DOCUMENT CHANGE REQUEST

DCR number 381	Changes required for: General	Originator: S Jeffery
Date: 2007/10/16	Date sent: 2007/10/16	Organisation: ESA/ESTEC
Status: IMPLEMENTED

Title:	Transistors Field-Effect N-Channel, based on types 2N4391/2N4392 and 2N4393		
Number:	5205/003	Issue:	1

1.6 PHYSICAL DIMENSIONS AND TERMINAL IDENTIFICATION

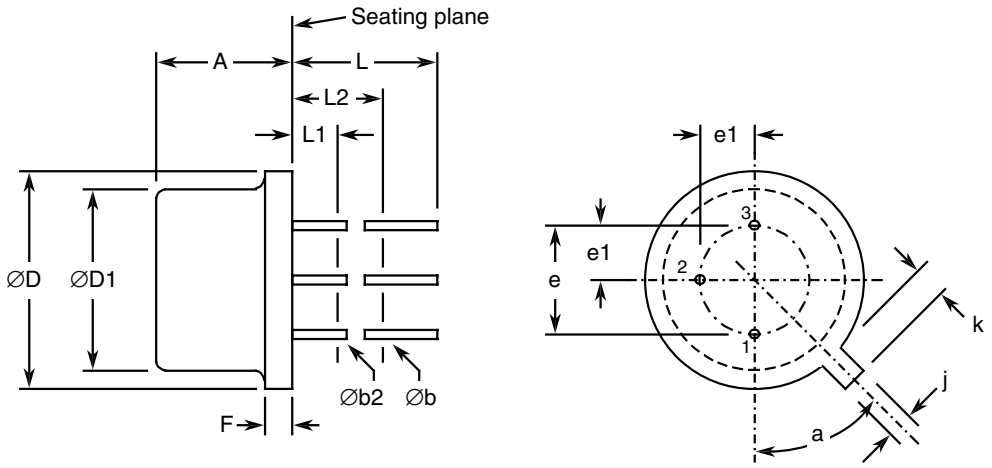
8. Figure 2 re-named "Physical Dimensions and Terminal Identification" and amended to reflect the 'standardised' TO-18 package. Notes amended.

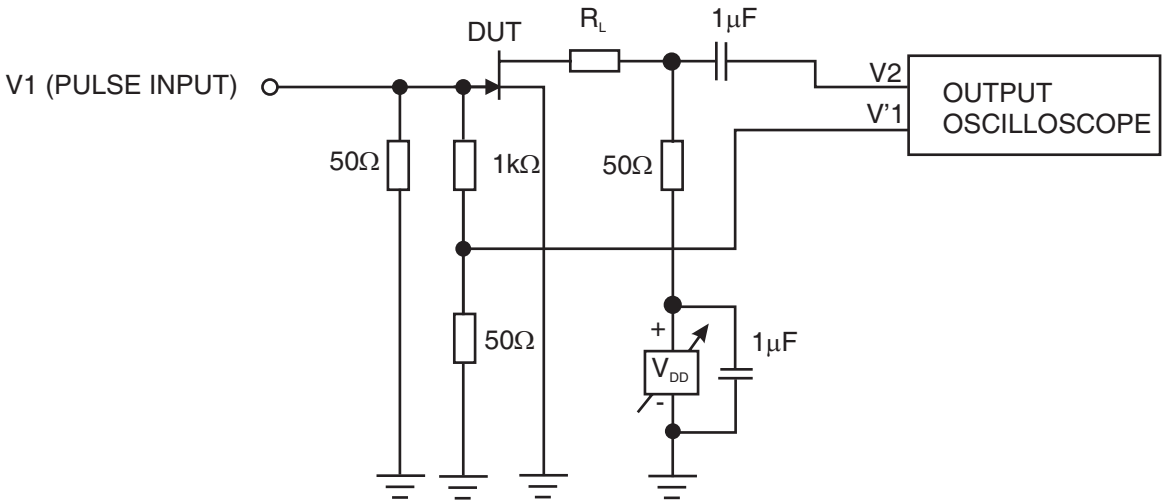
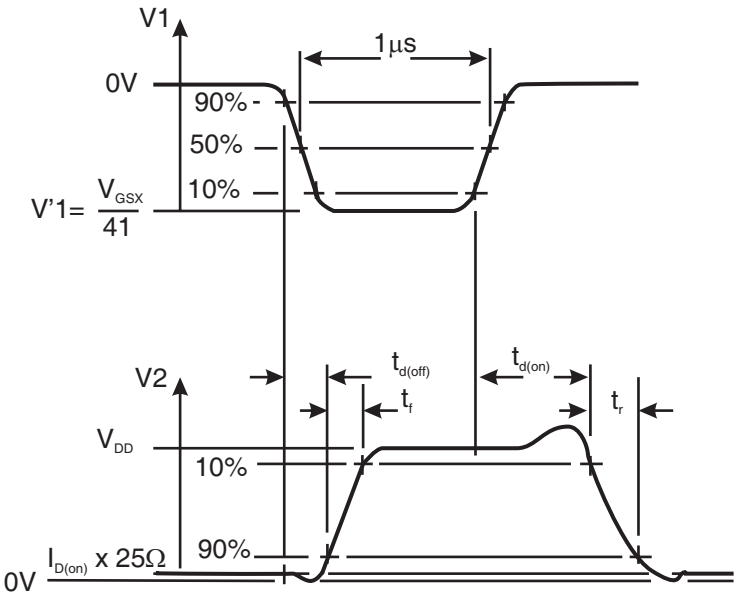
25. Figure 4 amended and moved to be a note (Note 3) to Room Temperature Electrical Measurements.

3. t_r, $t_{d(on)}$, t_f and $t_{d(off)}$ shall be measured using the following test circuit. The input waveform shall be supplied by a pulse generator with the following characteristics: Z_{out} = 50Ω, $t_r = t_f \leq$ 500ps, Pulse Width = 1µs, Duty Cycle = 10%. The output waveform shall be monitored on an oscilloscope with the following characteristics: Z_{in} = 50Ω, $t_r \leq$ 400ps.
